PREPARED	NAME	PAZMANY AIRCRAFT CORPORATION — SAN DIEGO — CALIFORNIA —	MODEL NO. PL-9
CHECKED		ENGINEERING CHANGE NOTICE 3	REPORT NO.
APPROVED			PAGE NO. 1

DWG 9-10-002-SHT 1

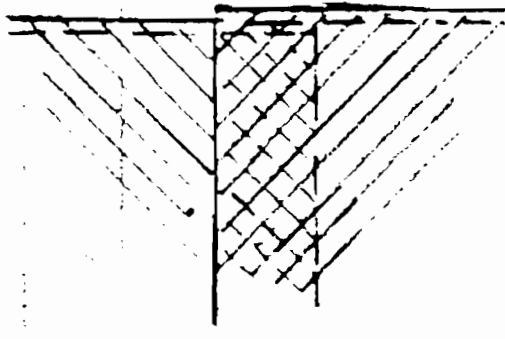
ZONE 6-B.

ZONE 4-B

END OF SKIN

-99

118.50

END OF SKIN

-101
